CAMDEN ROAD – NMA DESIGN DOCUMENT

CONTENT:

1. Typical shower rooms layouts compliance
2. Proposed reduced overall building height:
and additional maintenance access ladder.
3. Proposed revised cladding tile module
4. Proposed alternative finishes to rear elevation wall/deck.
5. Proposed omission of service risers along walkway.
6. Proposed revised setting out of stair core service risers.
7. Proposed larger footprint of stair core.

CAMDEN ROAD – shower rooms

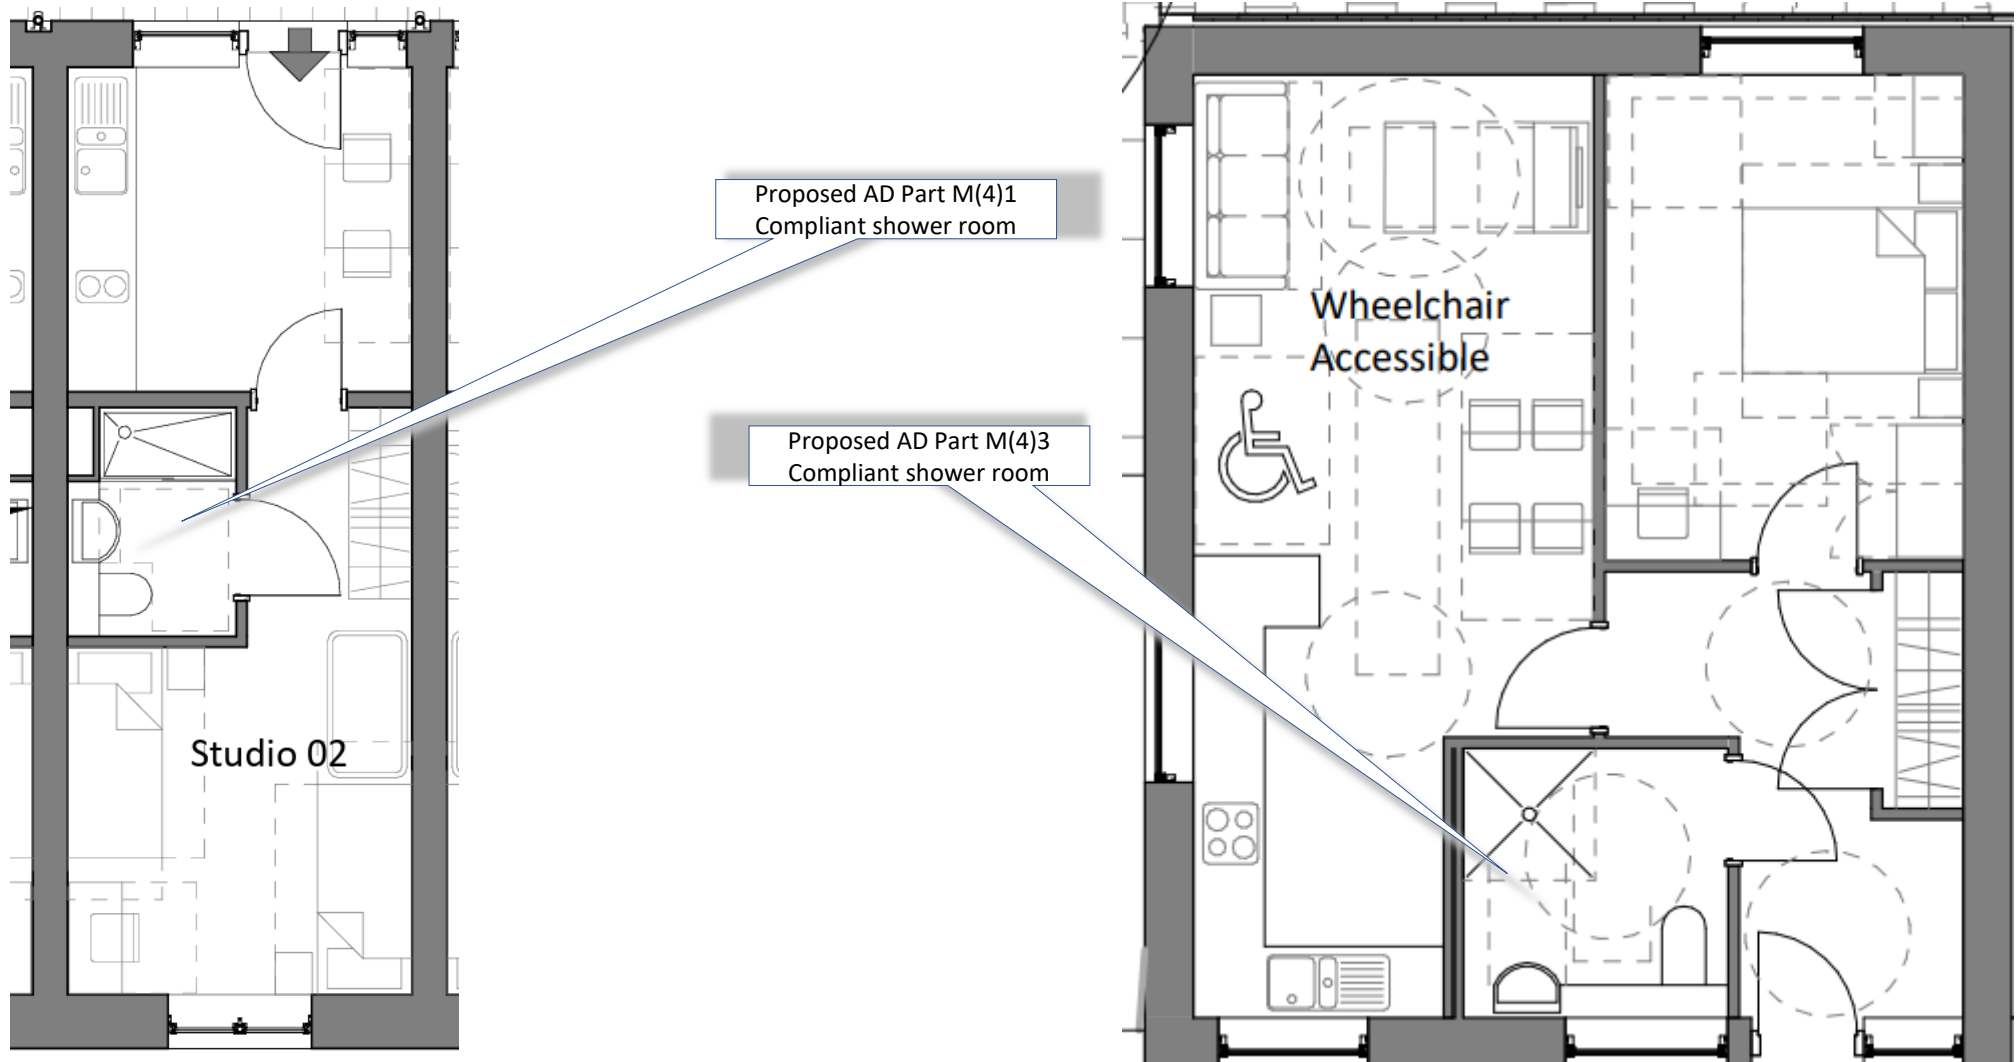
1. Typical shower rooms layouts compliance.

Sui Generis use class is not subject to compliance with AD Part M and it is evident that the unit layouts developed by the original architects working closely with the LBC Homeless Team were not designed to achieve AD Part M4(2) compliance. The shower tray arrangement was preferred by the client's Team as the most suitable for the units.

In order to achieve compliance with AD Part M4(2) a level access shower and a 300 mm unobstructed door nibs would need to be introduced which would have an impact of the internal circulation arrangements.

Based on the above comments we would apply to vary the wording of the Condition 4 pursuant to this planning permission 2020/3737/P to replace AD Part M4(2) reference with M4(1) Visitable Dwellings. The M4(1) compliant shower room layouts will be larger compared to the shower rooms shown on the approved drawings which will allow greater flexibility for the users.

CAMDEN ROAD – building height

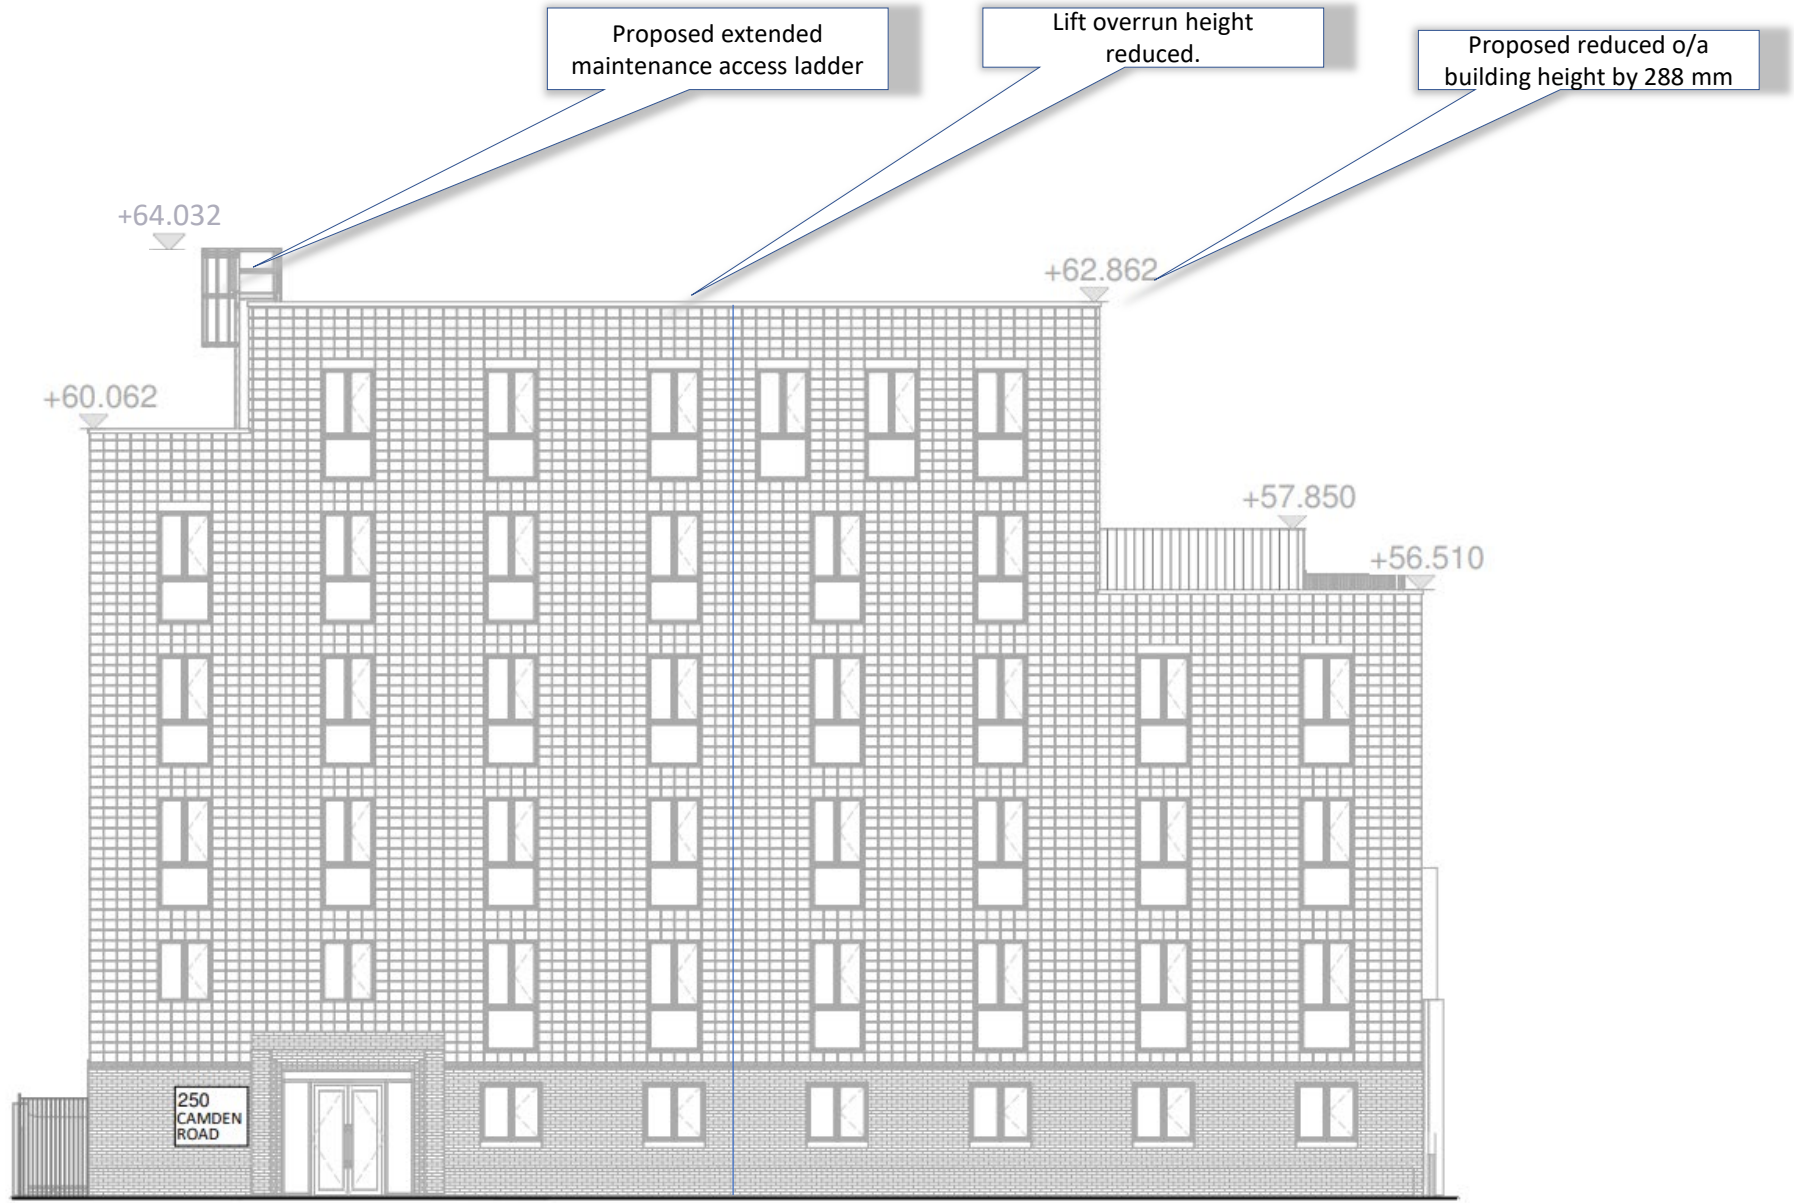
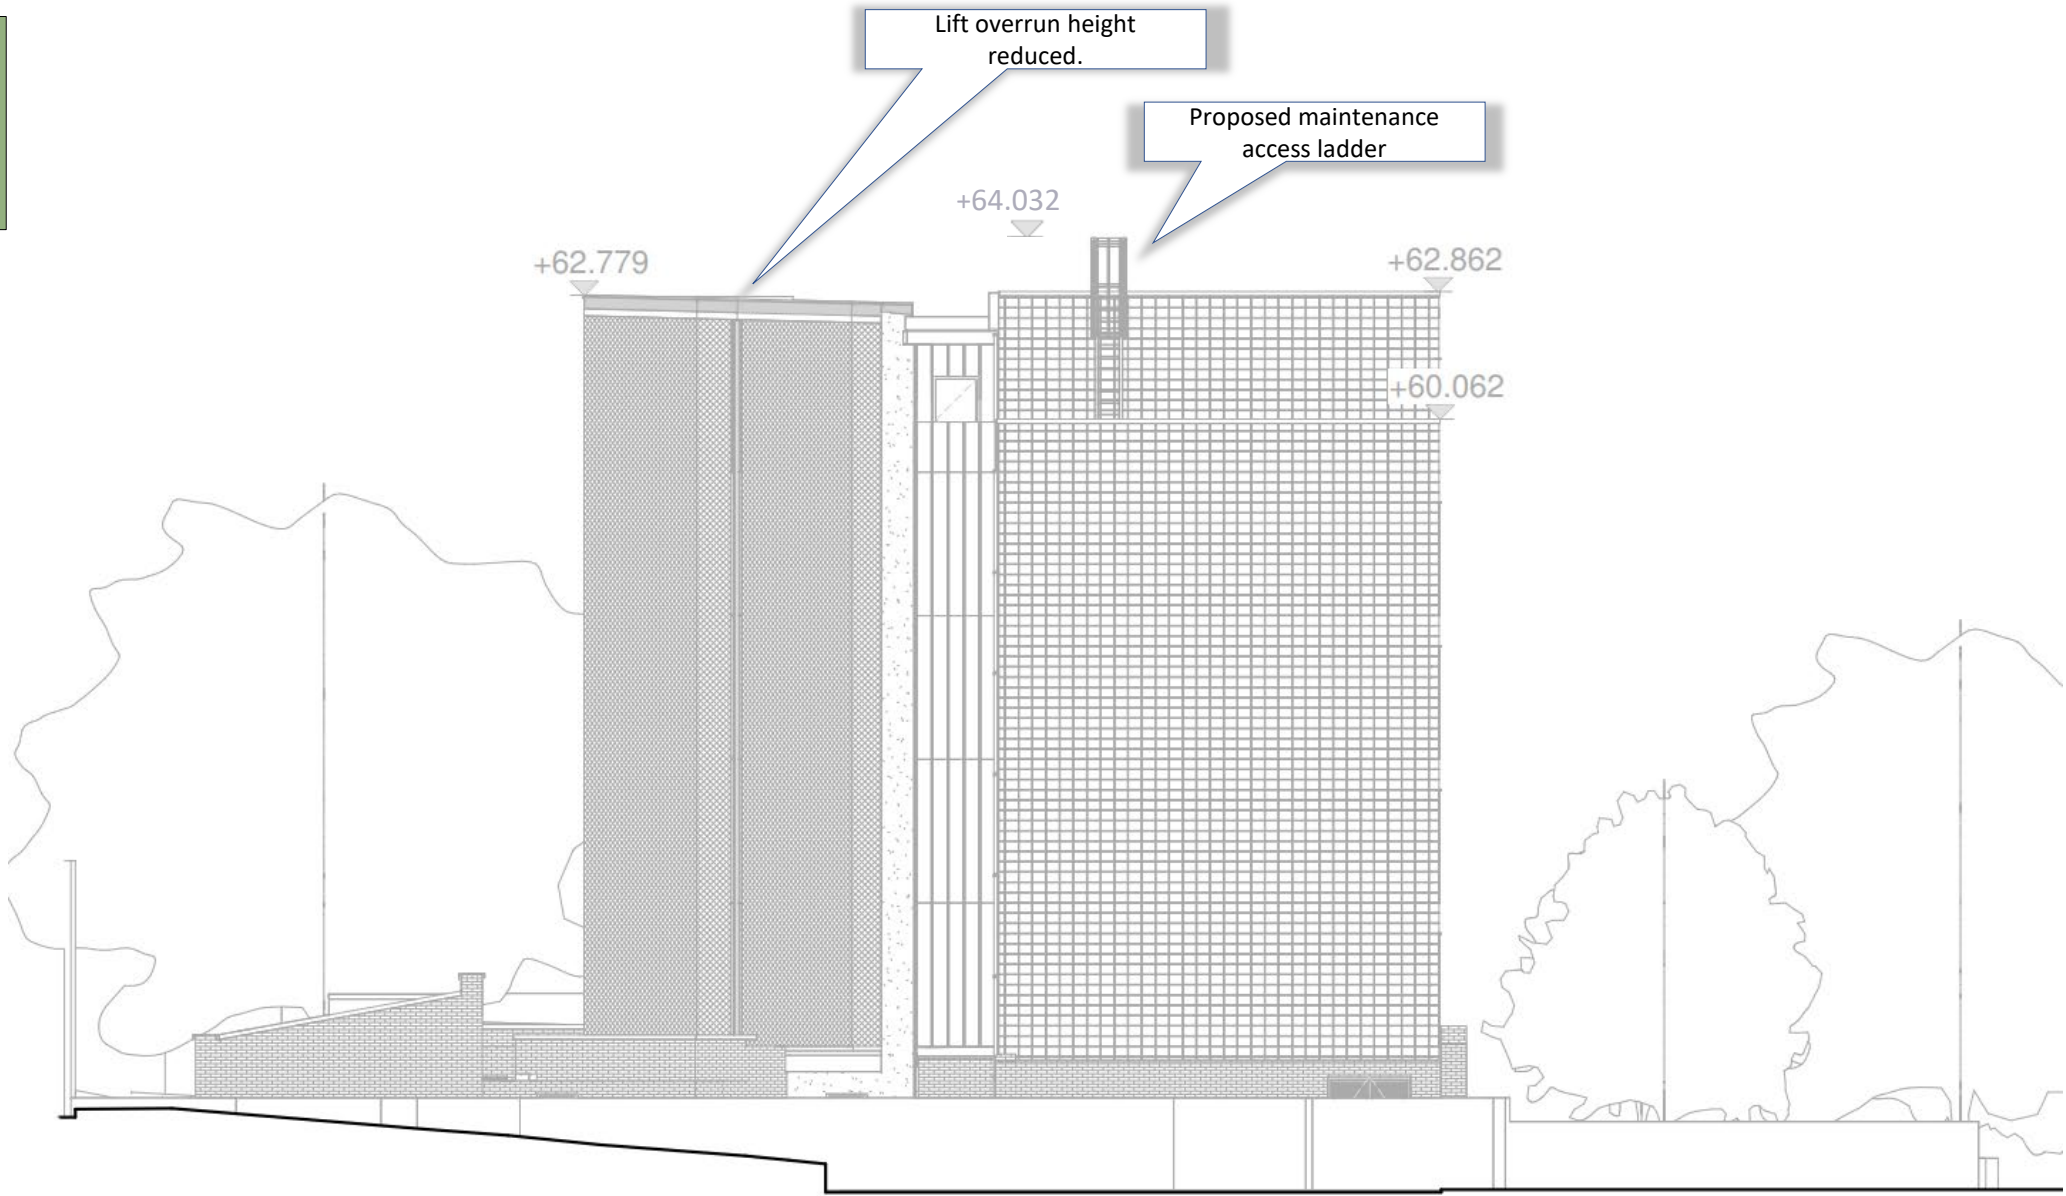
2. Proposed reduced overall building height and enlarged maintenance access ladder.

The current design is based on a Light Gauge Steel construction system (LGS). It allowed to avoid the duplication of the floor/ceiling spaces of the individual volumetric units, hence allowed for the reduction of the storey height.

The overall floor to floor height reduction allowed to achieve the lower whole building heights by 288 mm.

An extended maintenance access ladder will be required to provide safe roof access. The top section handrails will need to be extended by 1100 mm above the roof parapet level. The ladder will be constructed out of galvanised mild steel flat sections to achieve low maintenance finish.

Following Stage 4 design coordination with the lift manufacturer the lift overrun projection above the roof level has been reduced.

CAMDEN ROAD – external wall cladding module

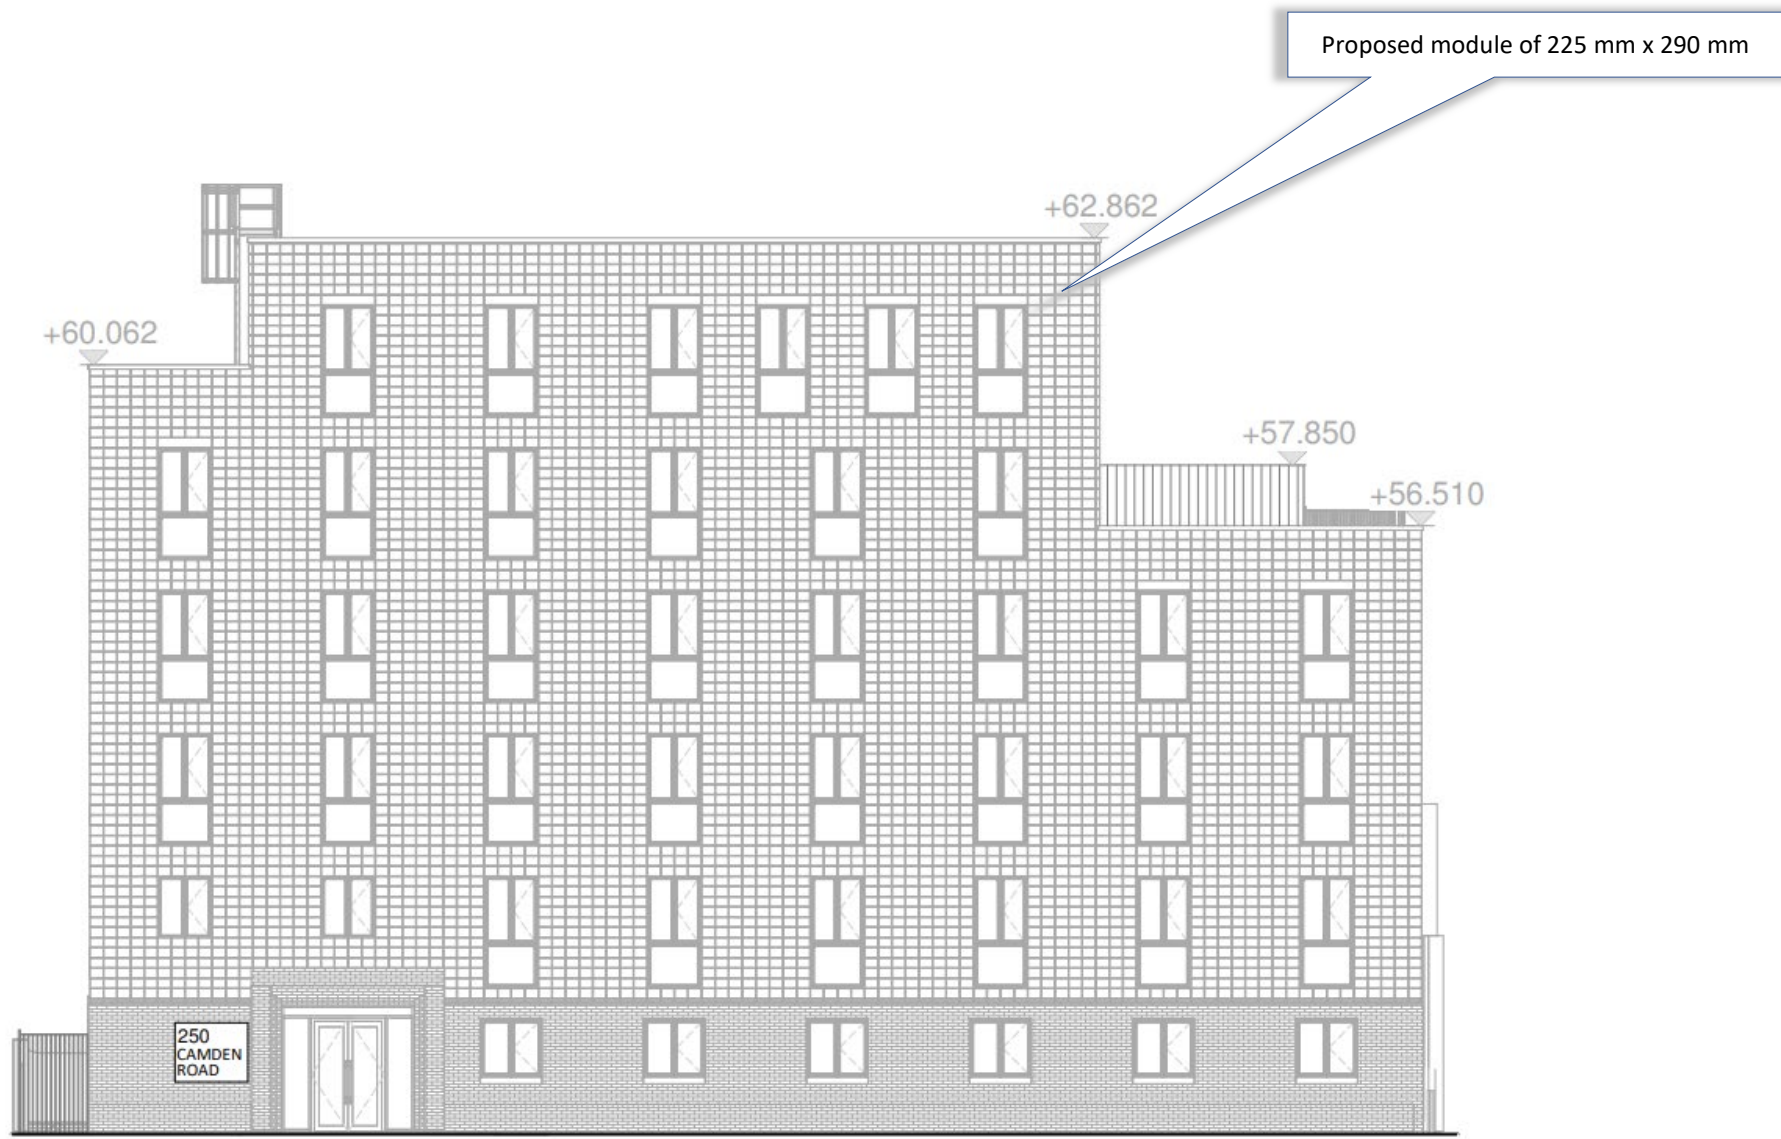
3. Proposed revised cladding tile module

In order to achieve a bonded joint cladding specification as per the proposed planning application finishes schedule, an alternative cladding system is proposed.

The proposed bonded joint finish cladding system which has a module of 225 mm x 290 mm as opposed to 250 mm x 290 mm shown on the approved drawings.

CAMDEN ROAD – floor finishes to rear elevation walkways

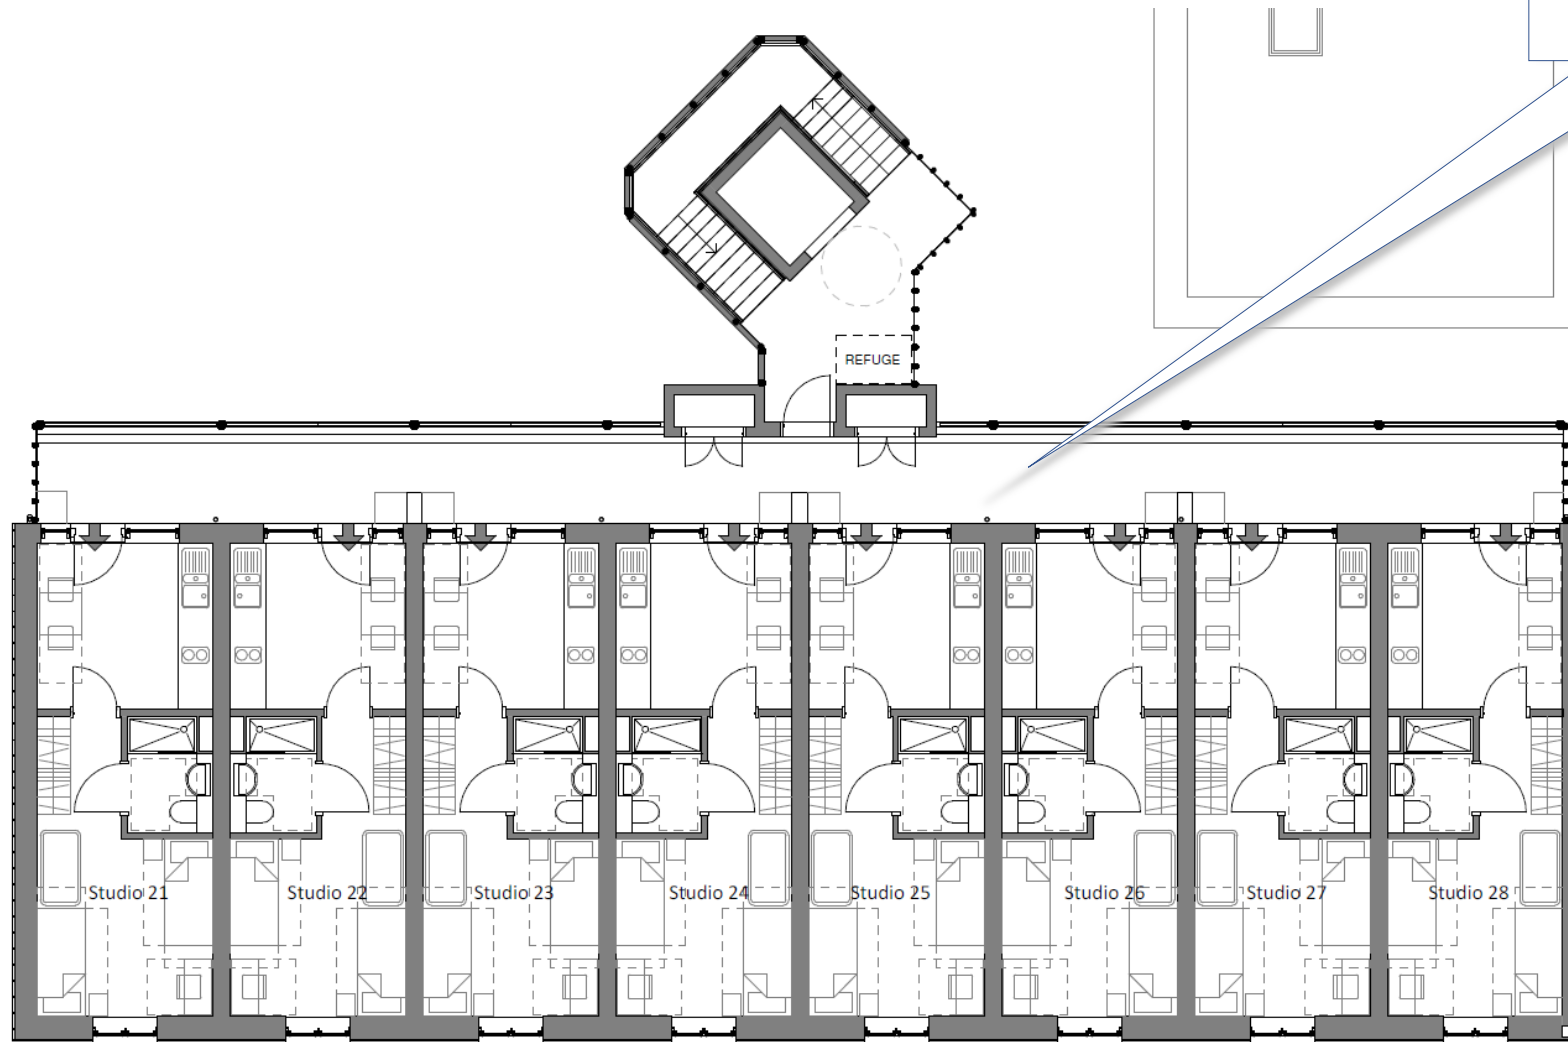
STO render is proposed instead of the specified ribbed/smooth Equitone panelling.

Reason: easier cleaning, repairs and construction. Also, the wall finish will be the same as the currently shown on Chester Road approved planning drawings.

Porcelain floor tiles are proposed in lieu aluminium plank system.

Reason: To minimise the risk of noise from foot traffic and to facilitate easier cleaning. The walkway floor finish will be the same as the finish proposed for Chester Road building shown on the approved drawings.
